ARCHITECT'S SUPPLEMENTAL INSTRUCTIONS

PROJECT:	The Reserves at South Lake New Apartment Complex Grinnell, IA	Report No.	One (1)
OWNER:	OPG South Lake Partners, LLC Dan Maximuk 234 N. Santa Fe Ave, Suite A Salina, KS 67401	Date	Nov. 14, 2022
CONTRACTOR:	MCP Group 3501 SW Fairlawn Rd. Topeka, KS 66614	Architect's Proj No.	20-3118
		Contract For:	General Construction Mechanical, Electrical

VE Items

A3.2

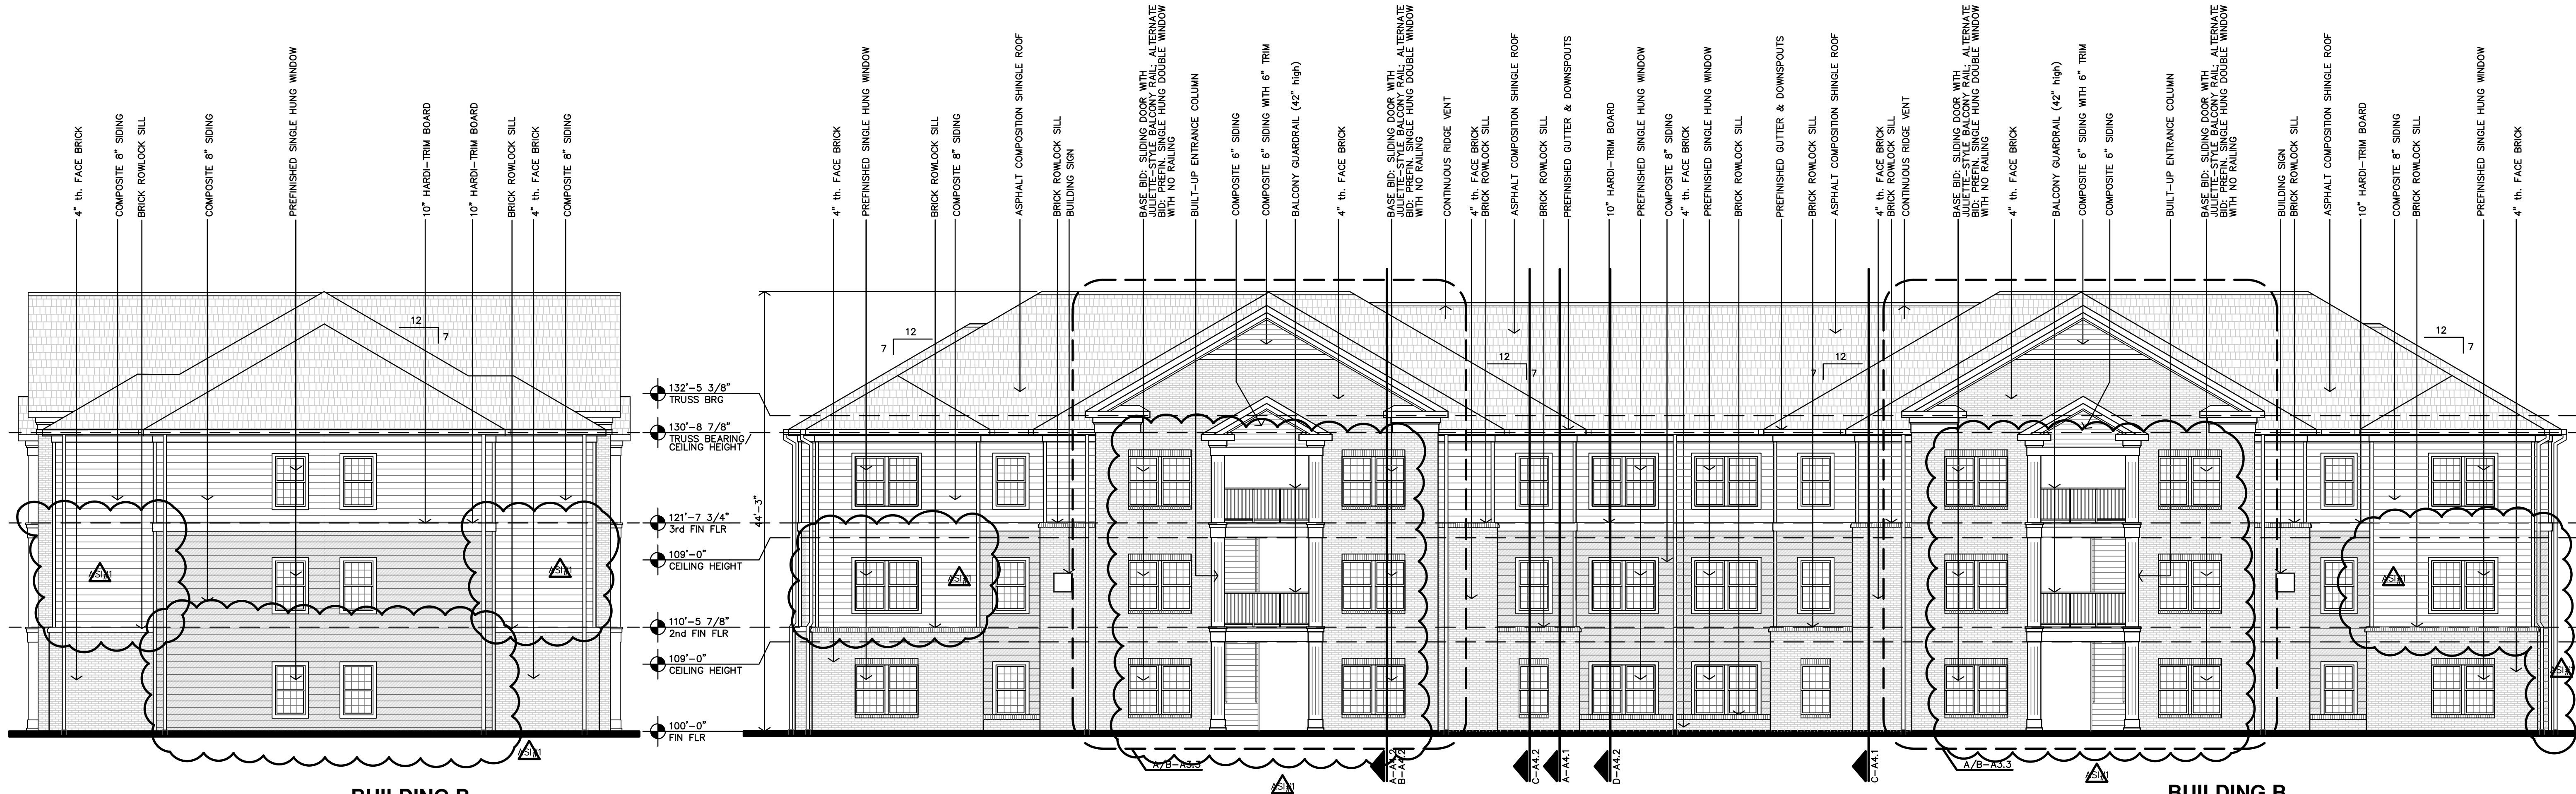
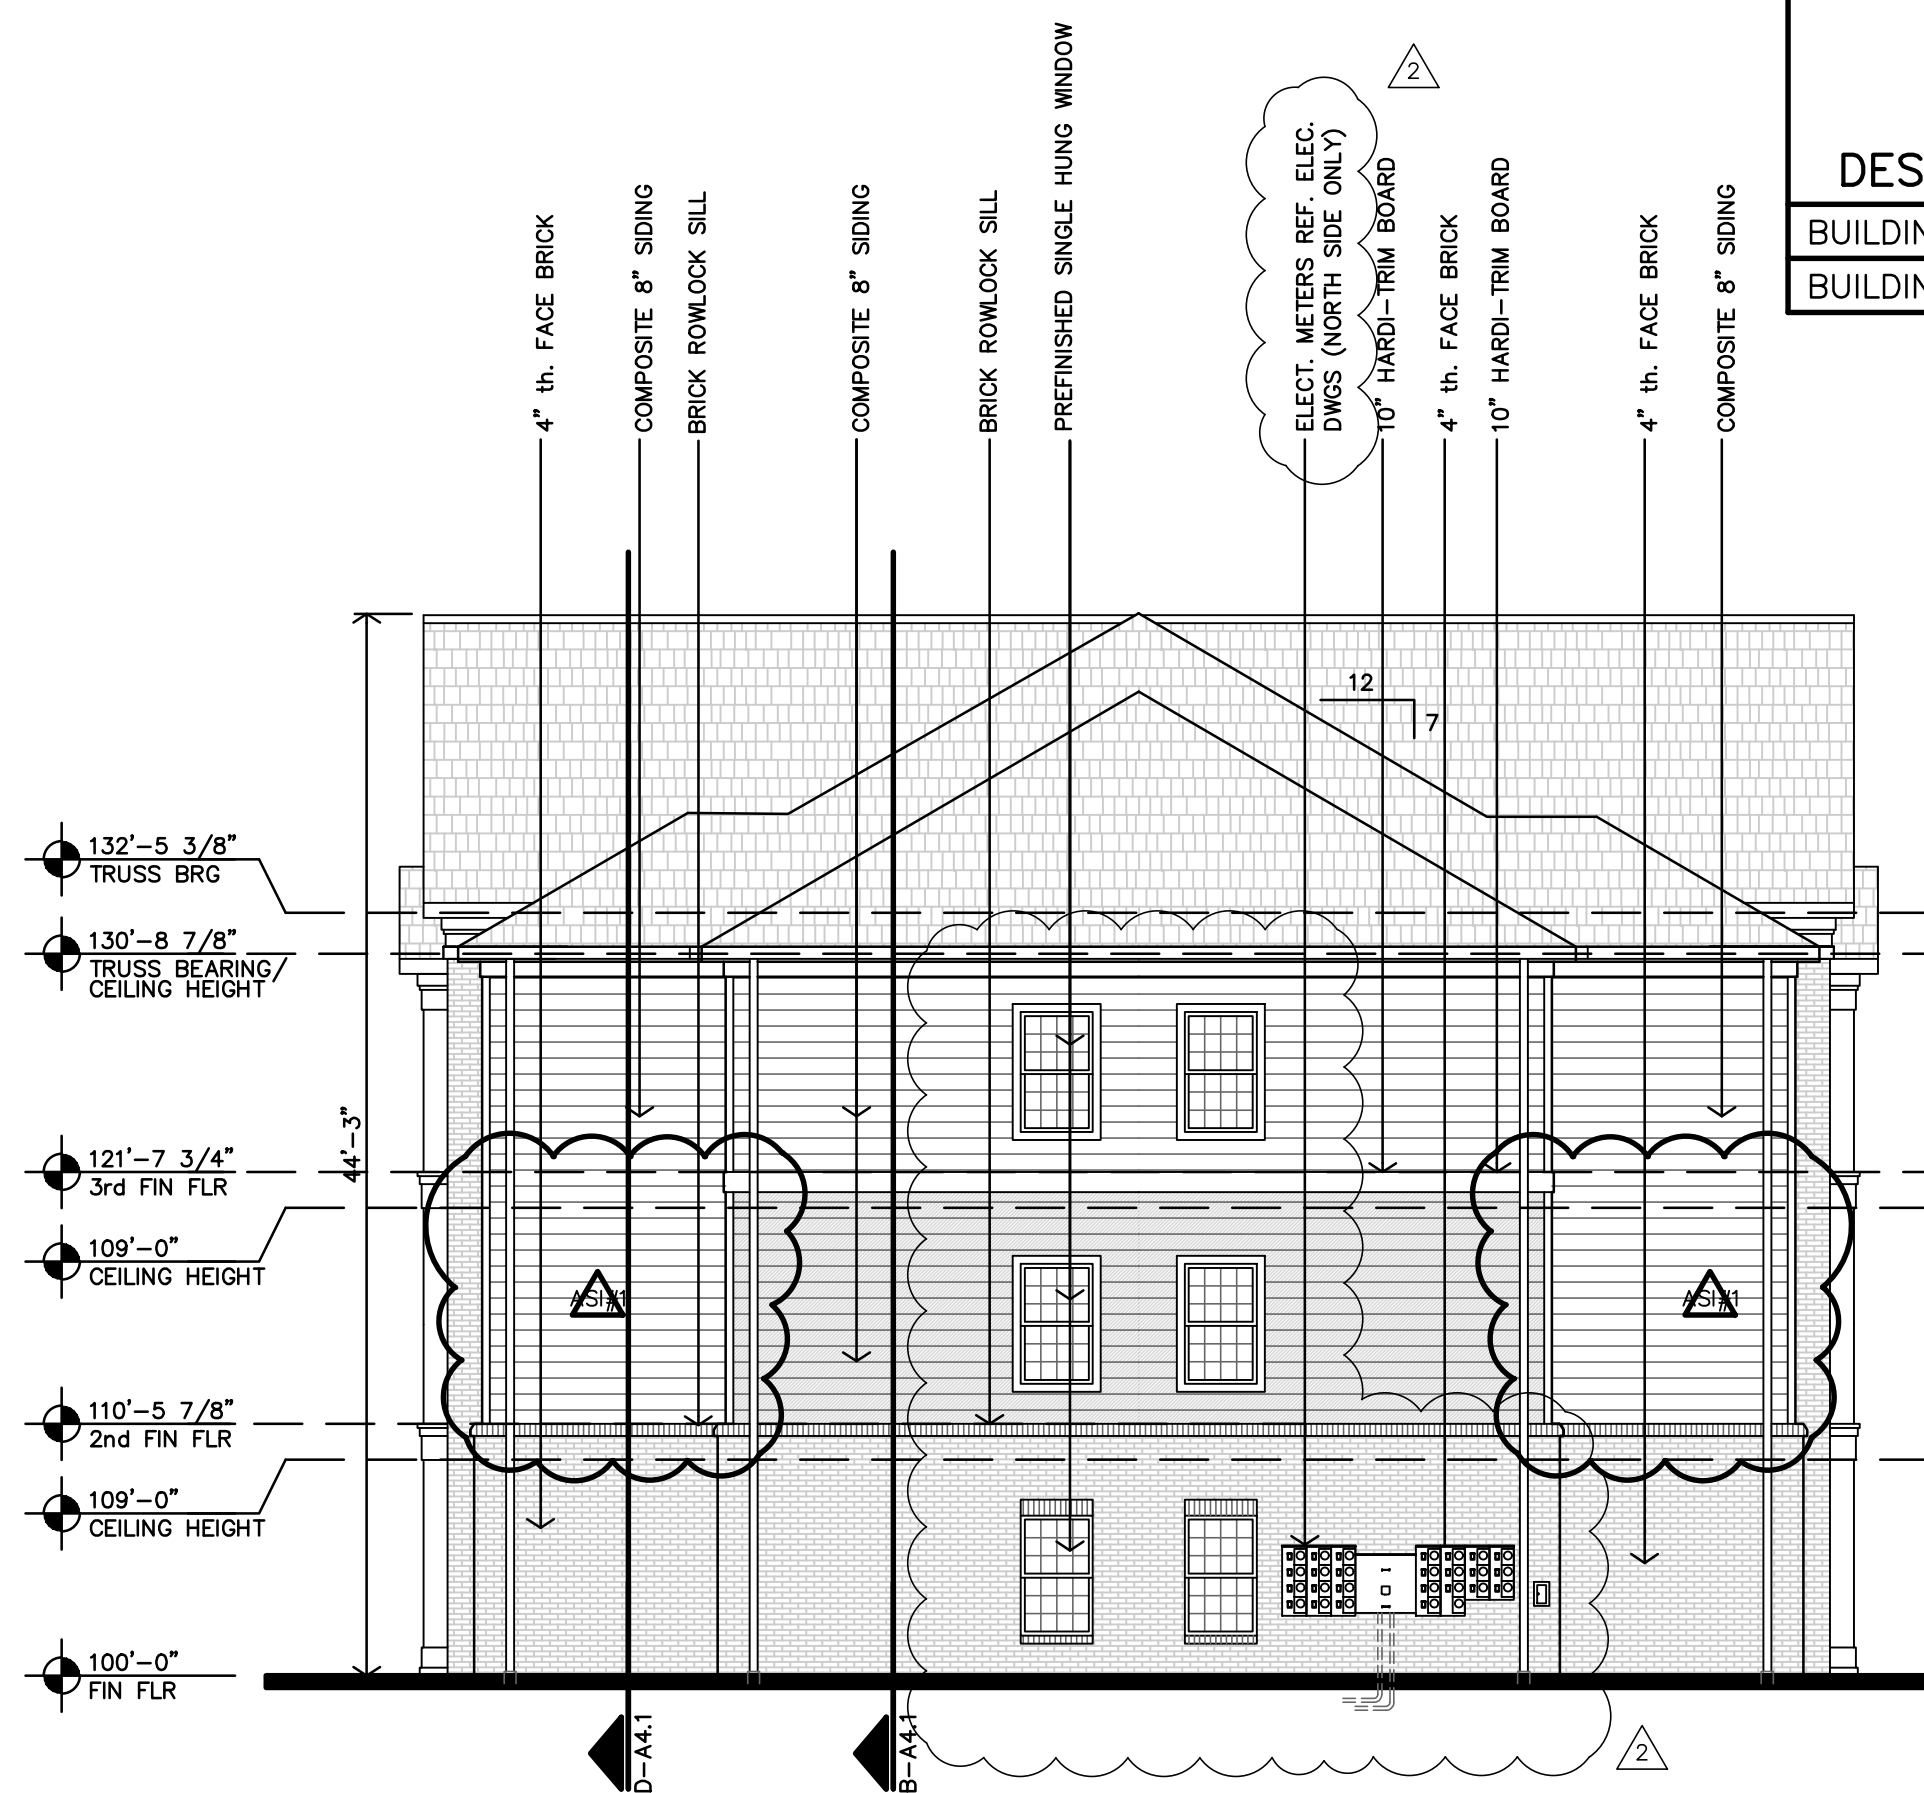
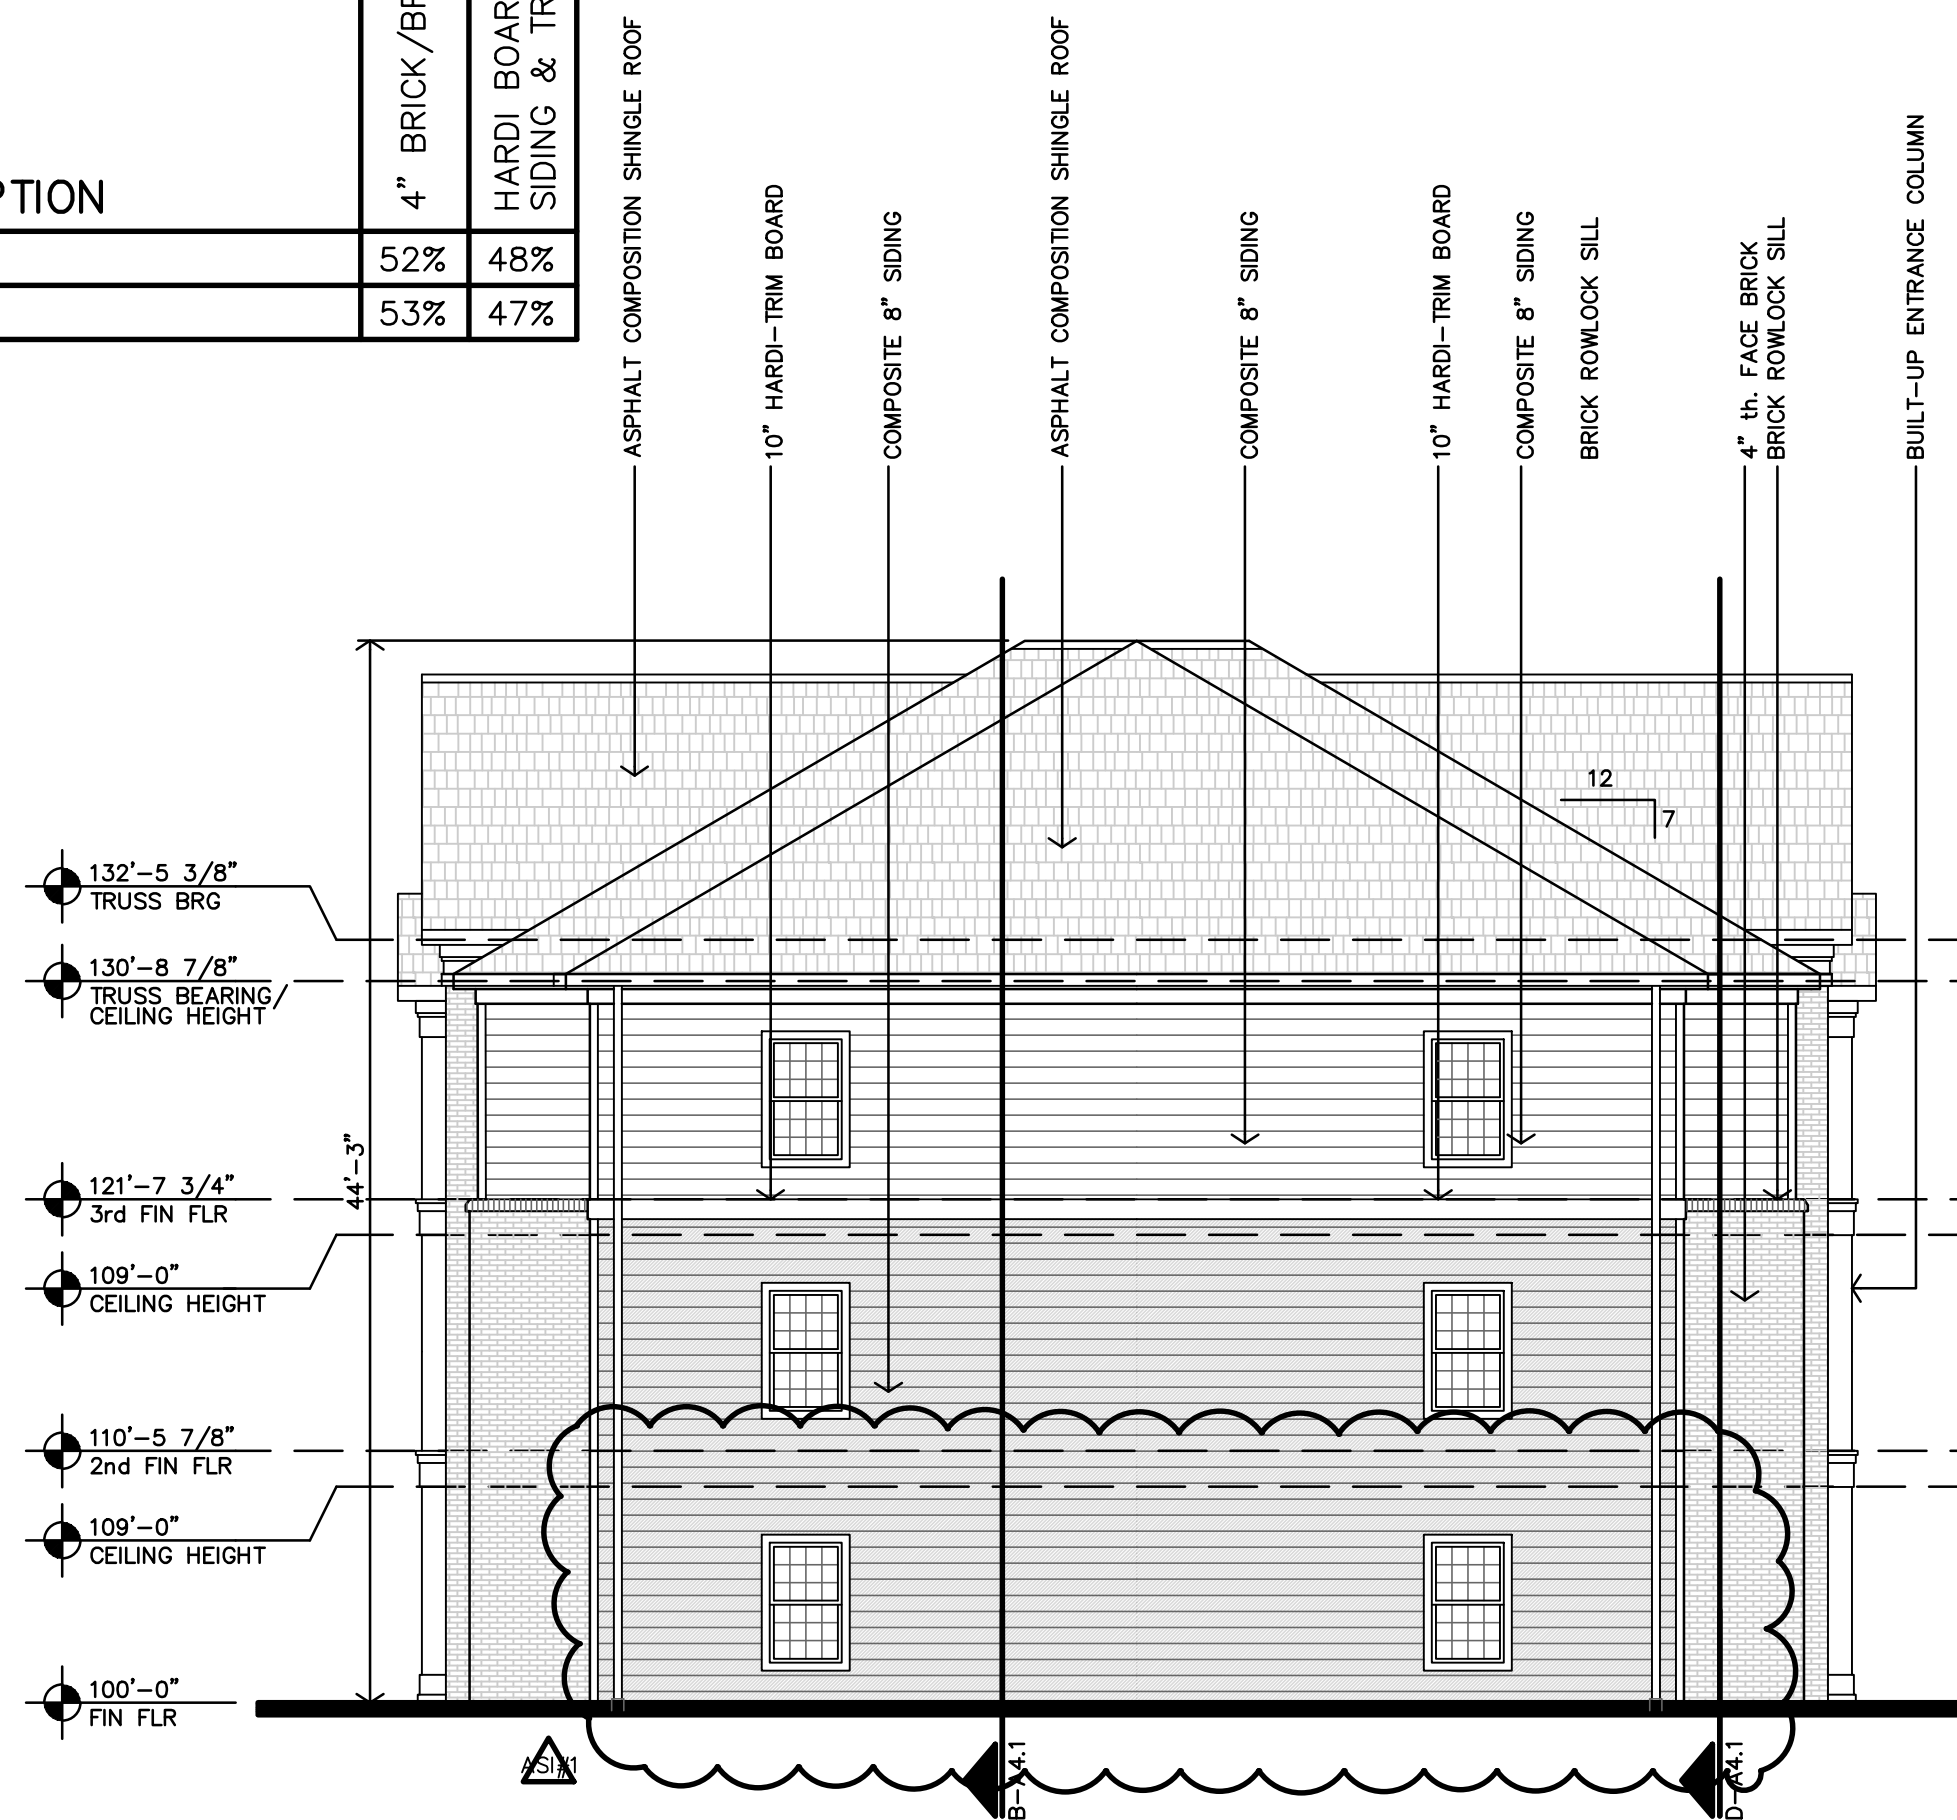
- a. Approx. 1,372sf brick veneer removed. Ref. sheet A3.1 & A3.2
- 5) Delete patio doors & Juliet rails
 - a. Alternate #3 selected.
- 6) All electric
 - a. Alternate #4 selected, Issued per Addendum #2 & #3
